[FI] S.16 Planning Application No. A/NE-TK/832 - Further Information

**1<sup>st</sup> Further Information**

**Proposed Temporary Holiday Camp, Place of Recreation, Sports or Culture  
(Barbecue Site and Hobby Farm) and Eating Place with Ancillary Facilities for a Period of 3 Years  
and Associated Filling of Land in "Agriculture" and "Open Space" Zones and Area shown as 'Road',  
Various Lots in D.D. 17 and Adjoining Government Land, Ting Kok, Tai Po, New Territories**

**(S.16 Planning Application No. A/NE-TK/832)**

+7.9 EXISTING LEVEL

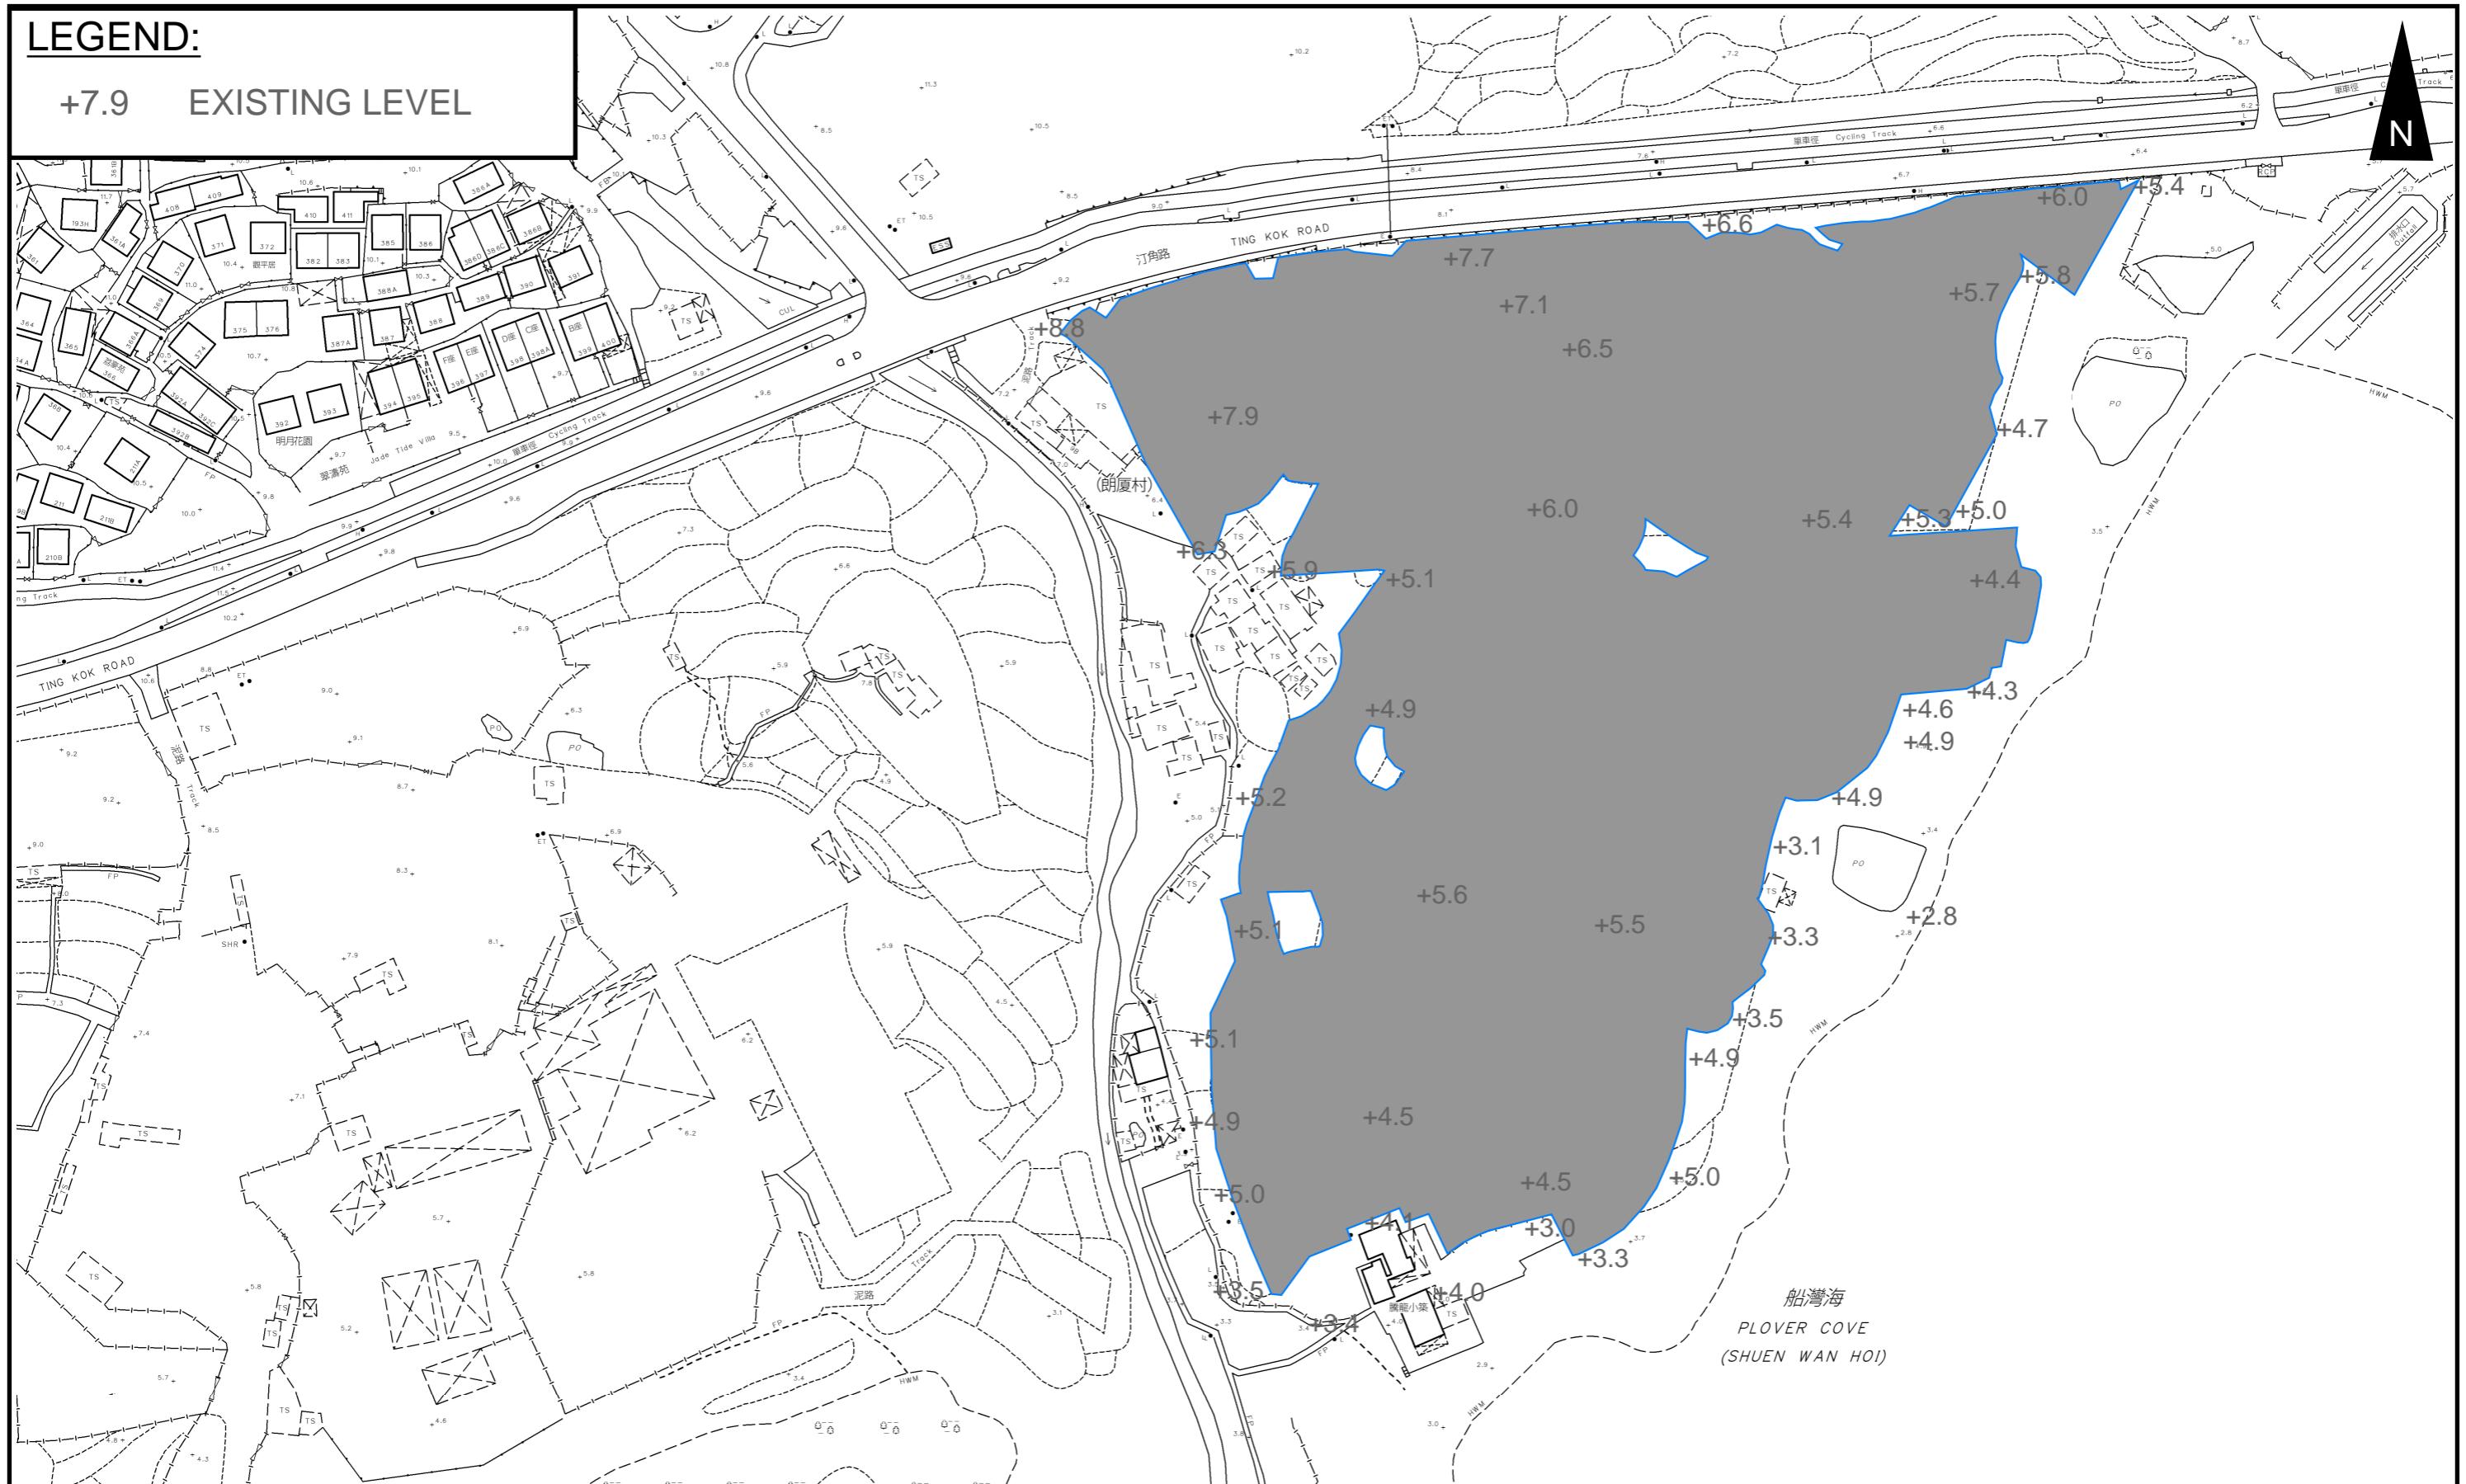
(d)	Please provide topography of the application site and adjacent areas before and after the proposed development.	Noted. Further to the discussion with DSD, Figure 6 shows more existing levels around the Site for your perusal.

**PHOTO 1**

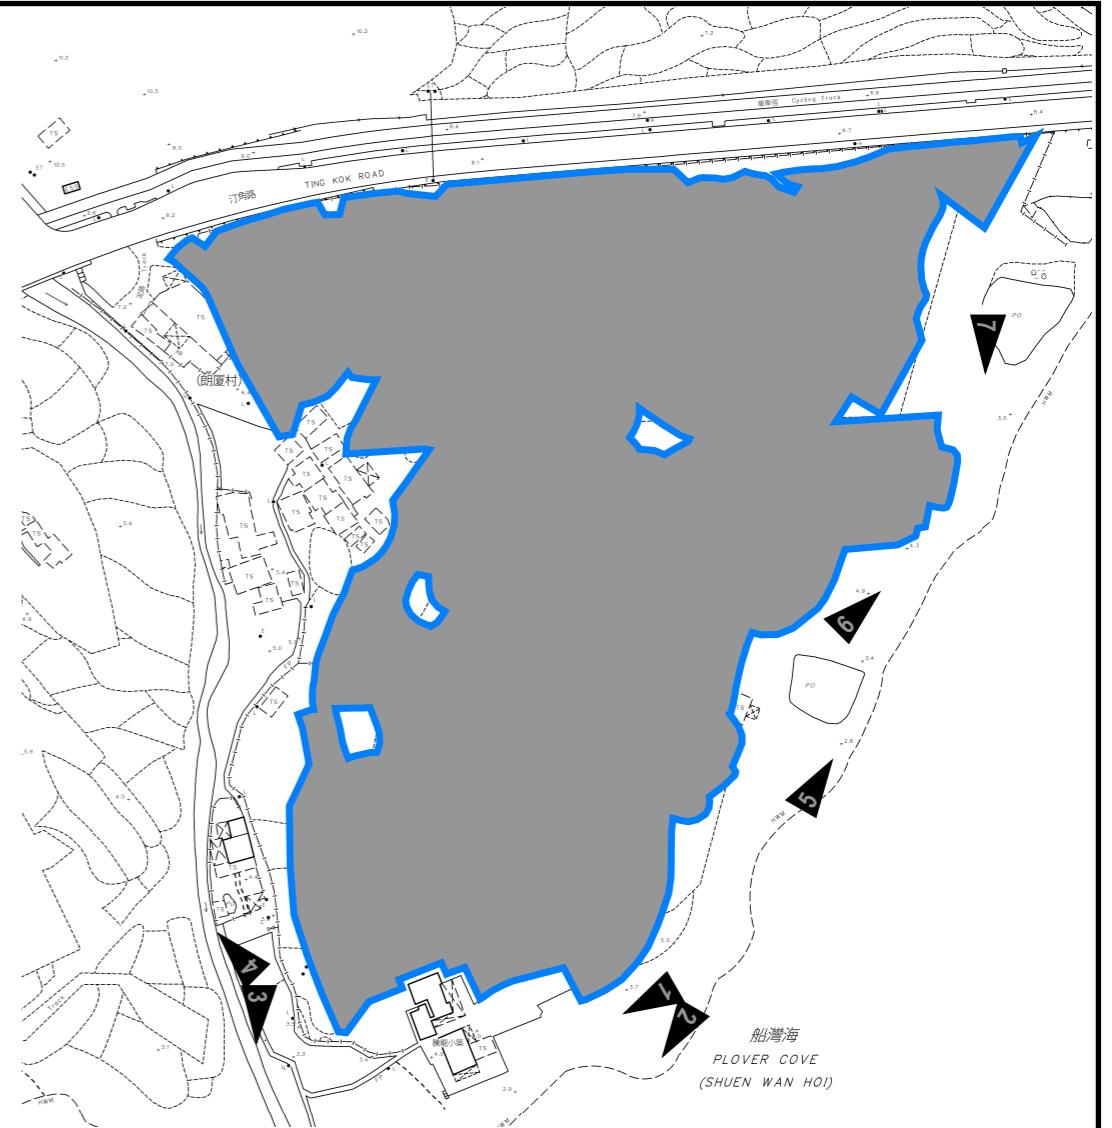
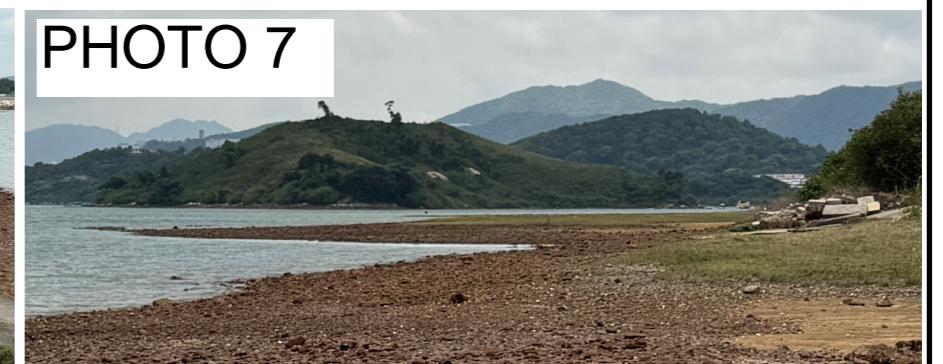
(e)	Please provide sufficient site photos showing the details of the existing stormwater drainage system proposed to collect and discharge the runoff from the application site.	Noted. Please refer to Appendix D.
